# **Final Supplemental Environmental Impact Report**

***Volume 8***  
***Chapter 7 – Responses to Comments***

**Golden Queen Mining Co. Inc., Soledad Mountain Project**

**RE: Supplemental Environmental Impact Report - Response to Comments - Revised Soledad Mountain Project by Golden Queen Mining Co., Inc. (PP08210)**

Figure 3-15  
**Stage 1 Channel Construction Plan**

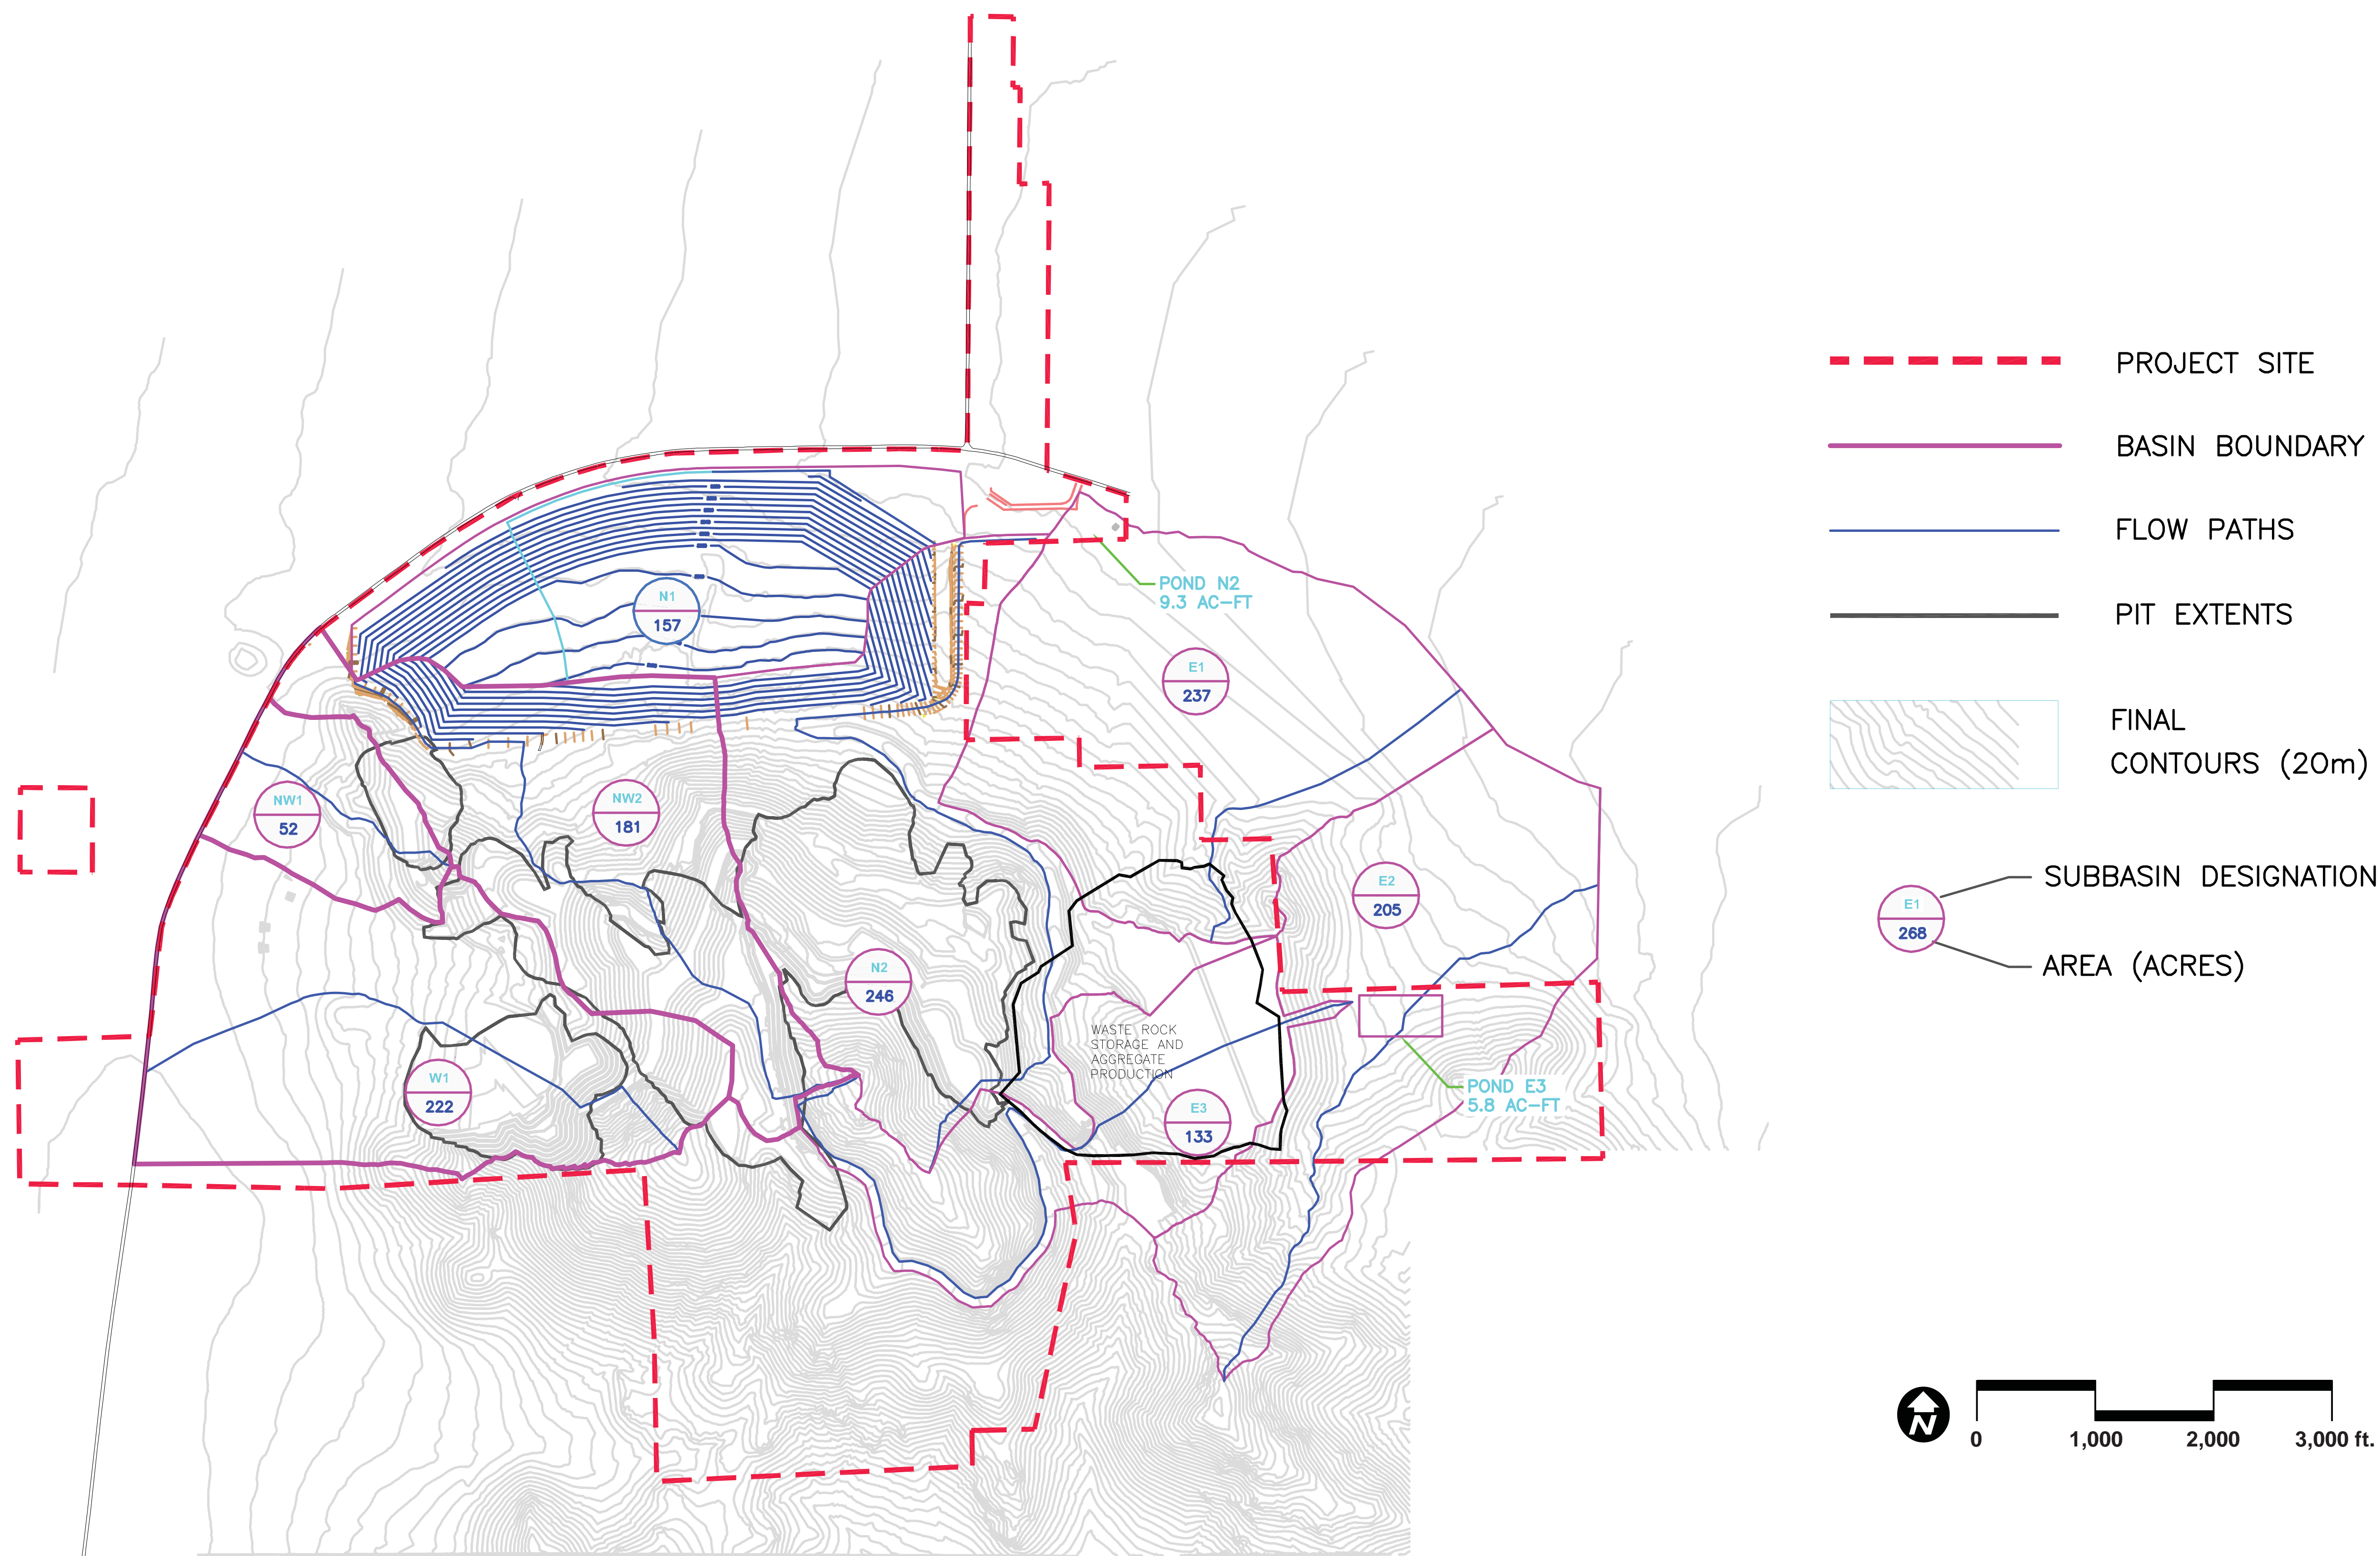
- All figures should have thorough explanations and show information referenced in the text of the document. For example:
    - Figure 3-15, *Stage 1 Channel Construction Plan*, shows existing contours in the explanation but they are illegible on the map. Additionally, a set of contours in the general location of the proposed heap leach pad are not referenced in the explanation or labeled on the map.

- The text on page 3-39 of the DSEIR states that a heap leach pad channel that extends approximately 7,000 feet along the northerly site boundary is shown on Figure 3-16, *Post-Mining Drainage Plan*, however, the figure only shows the general location of flow paths without the pertinent drainage features referenced in the text.

- The preliminary layout and drainage associated with the crushing-screening plant, workshop and warehouse, fuel storage, equipment wash slab and laboratory are shown on Figure 3-16 (Post-mining Drainage Plan). A number of the facilities are located up gradient from the Phase 1 pad. Runoff originating above these facilities will be collected in ditches and routed both east and west around the perimeter of the pad.
